STAFF RECOMMENDATION
1502 Paris Avenue
August 18, 2021

Application: New Construction—Outbuilding
District: Belmont-Hillsboro Neighborhood Conservation Zoning Overlay
Council District: 18
Map and Parcel Number: 11704019000
Applicant: Paul Boulifard, Architect
Project Lead: Melissa Baldock , melissa.baldock@nashville.gov

<p>Description of Project: The applicant proposes a detached garage that is less than twenty feet (20') from the back of the house.</p> <p>Recommendation Summary: Staff recommends approval of the proposed outbuilding with the condition that staff approve all windows and doors, a brick sample, and the roof shingle color prior to purchase and installation; finding that with these conditions, the addition meets Section II.B of the <i>Belmont-Hillsboro Neighborhood Conservation Zoning Overlay: Handbook and Design Guidelines</i>.</p>	<p>Attachments A: Site Plan B: Floorplans C: Elevations</p>
--	---

Figure 3. The proposed roof dormers and their widths.

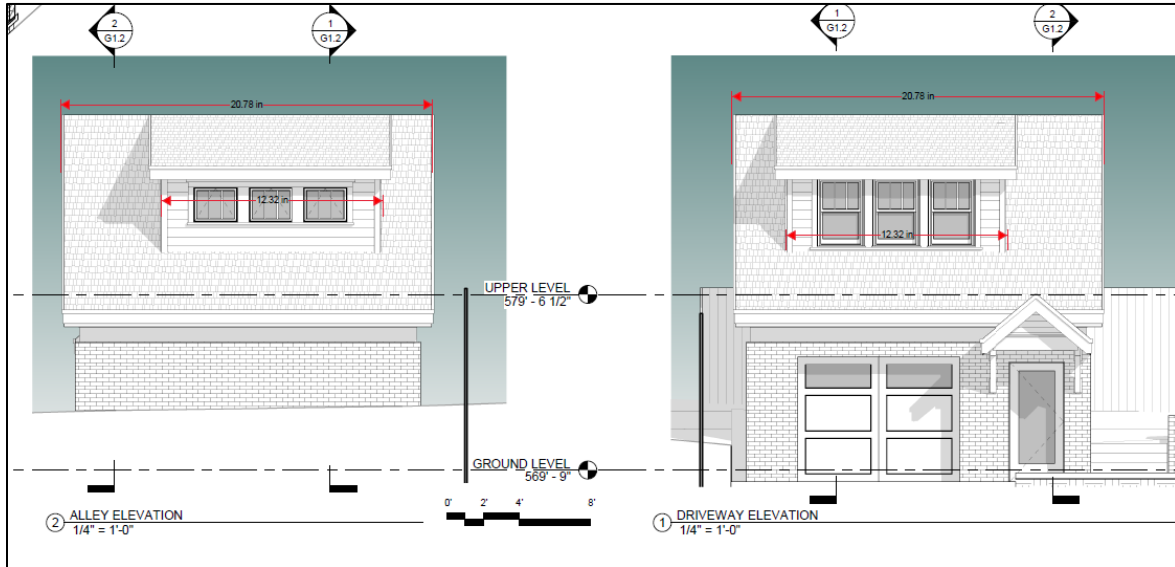
* The design guidelines for the Belmont-Hillsboro Neighborhood Conservation Zoning Overlay state that dormers should be fifty percent of the roof plane. The proposed dormers are slightly wider. The roof, as measured from eave to eave, is approximately

twenty feet, nine inches (20'9") wide, which means the dormer width should be approximately ten feet, four and a half inches (10' 4½") as measured from wall to wall. The applicant is proposing dormers that are approximately twelve feet, four inches (12'4") wide, as measured from wall to wall. In this instance, staff finds the additional width to be appropriate because of the small footprint of the building. The structure's footprint is four hundred square feet (400 sq. ft.) smaller than what is allowed under the design guidelines, and staff therefore finds that dormers that are two feet (2') wider than typically allowed are appropriate and do not result in an outbuilding that is out of scale.

1 ARCHITECTURAL SITE PLAN - PROPOSED -w/garage
1/8" = 1'-0"

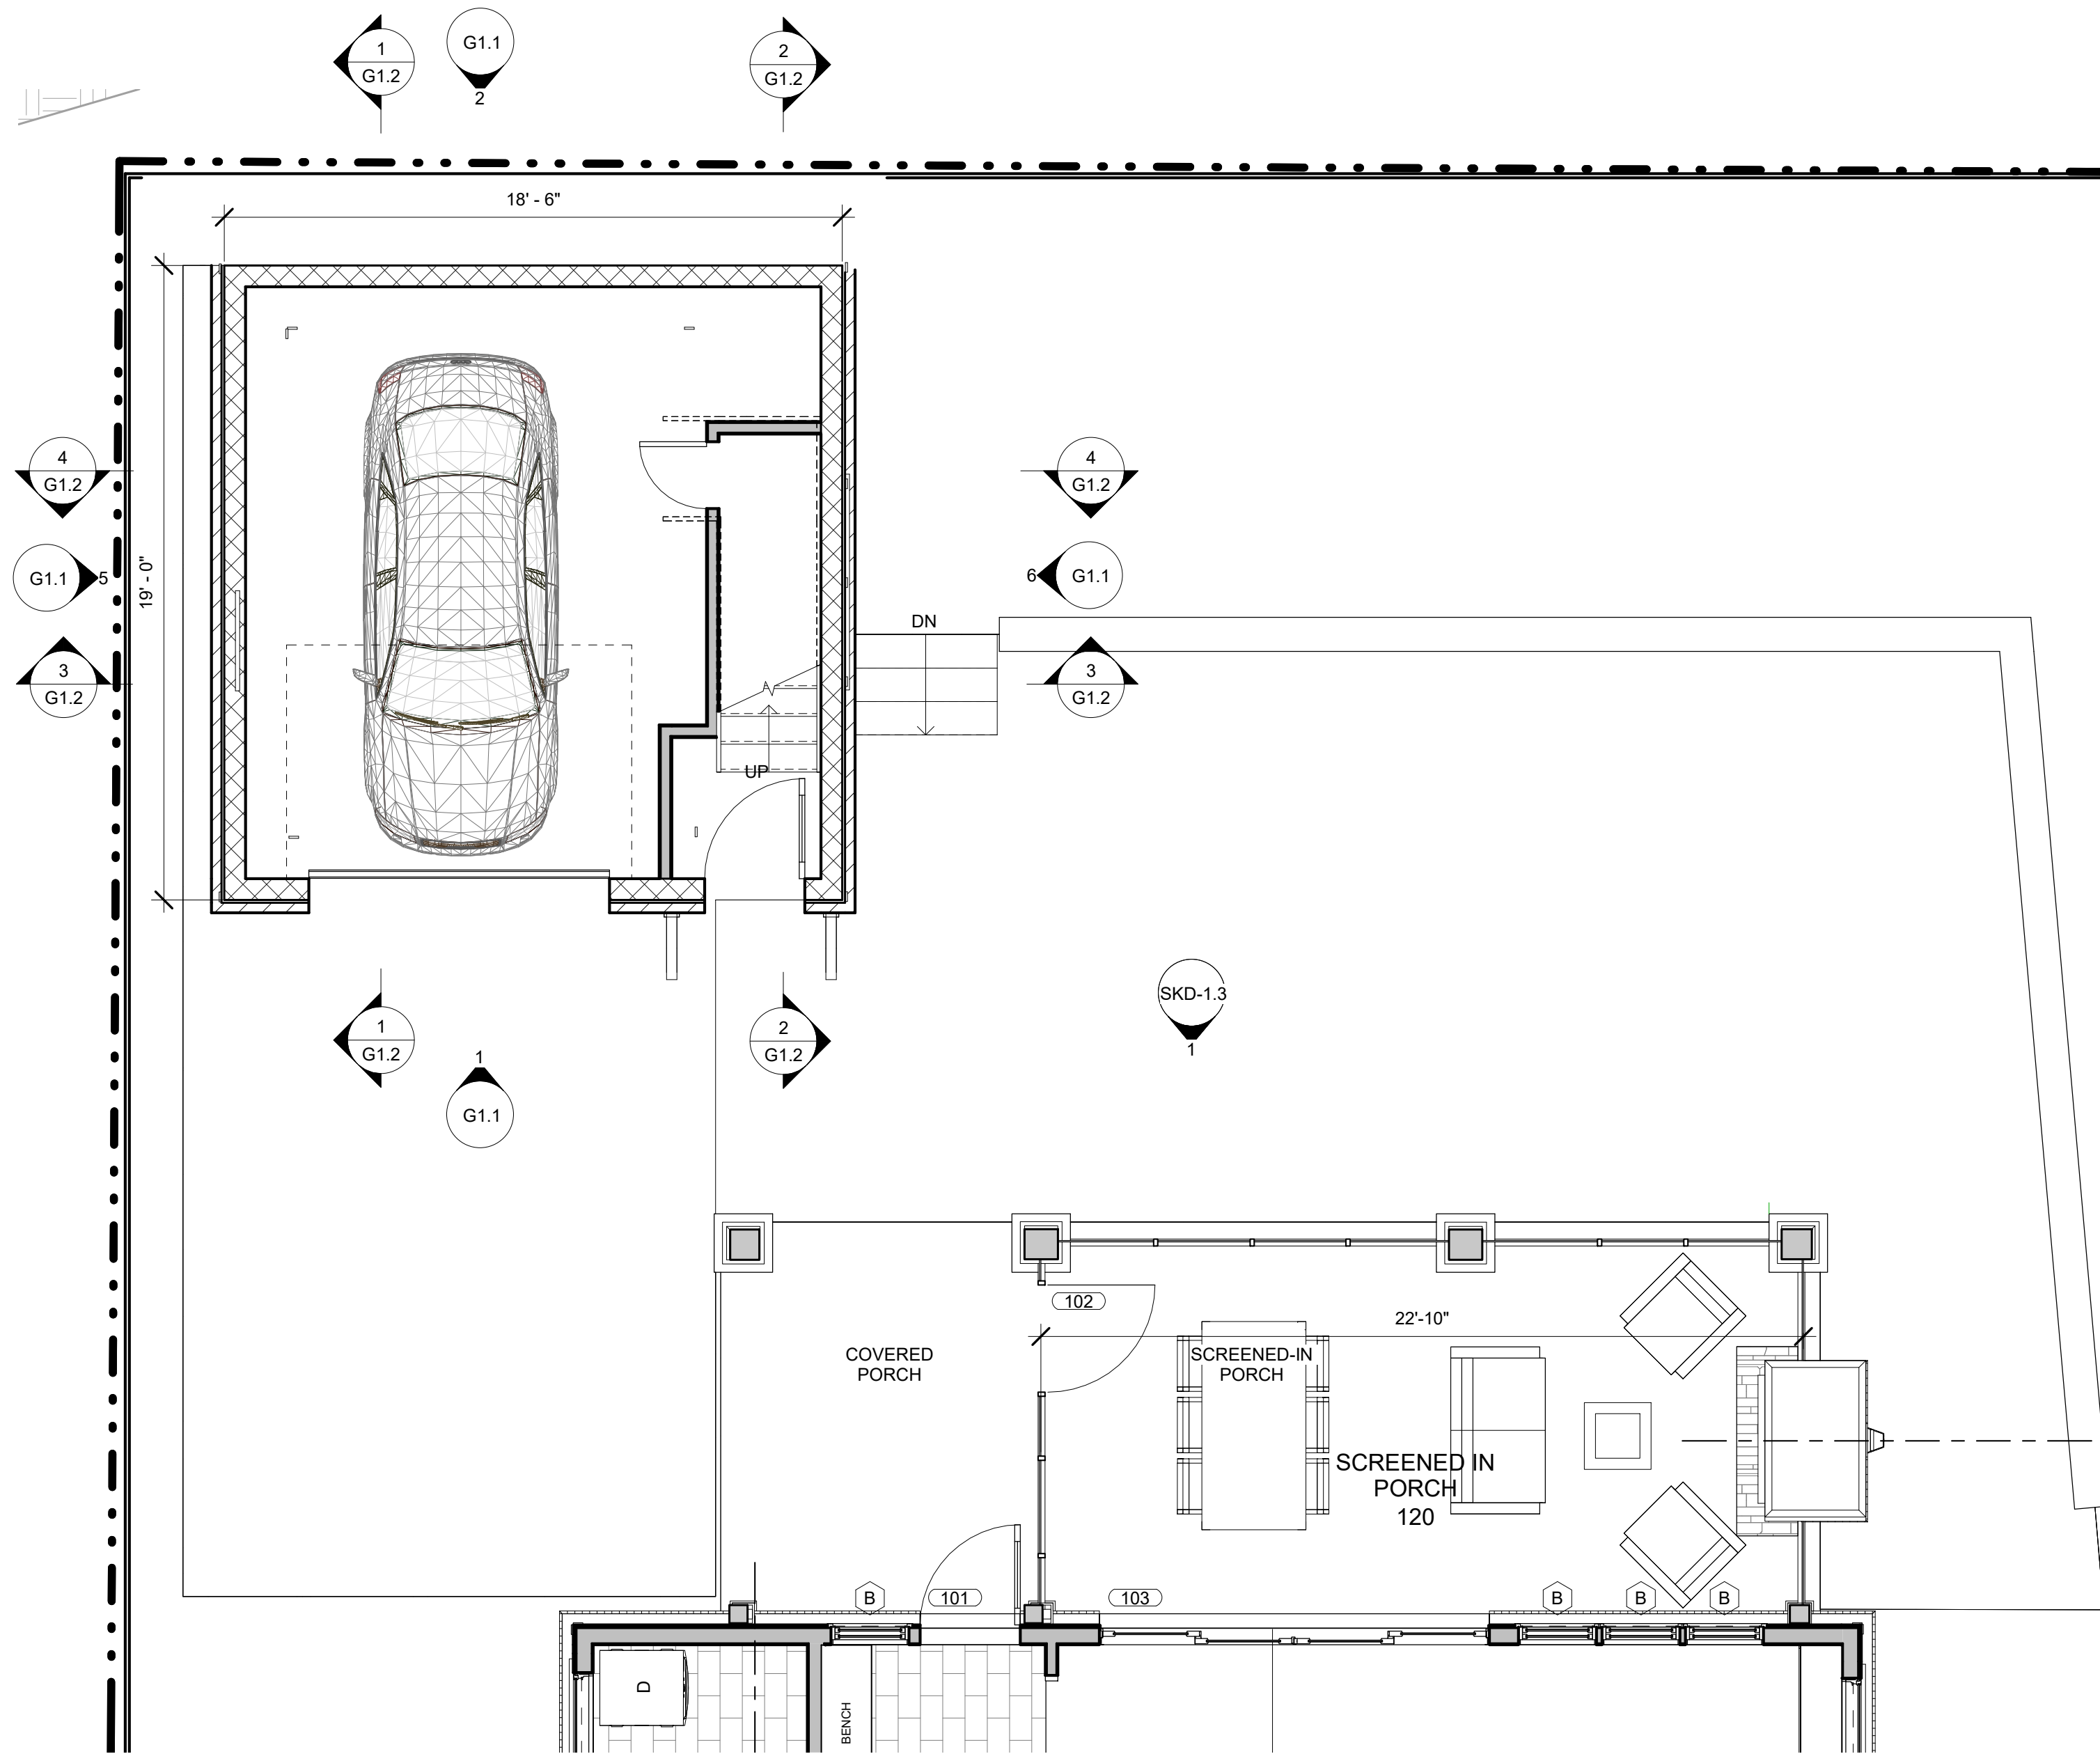
* The design guidelines state that there should be a minimum of twenty feet (20') between the back of the addition and any outbuilding. However, the applicant is

proposing a space of just ten feet (10'). Staff finds that the propose distance of ten feet (10') is appropriate for this site because this lot is just 130' deep and the Commission has approved a distance of ten feet (10') on similar lots. In addition, the overlap on the site plan where the structures are ten feet (10') apart is just approximately five feet (5'). The rest of the outbuilding is more than twenty feet (20') from the back of the house.
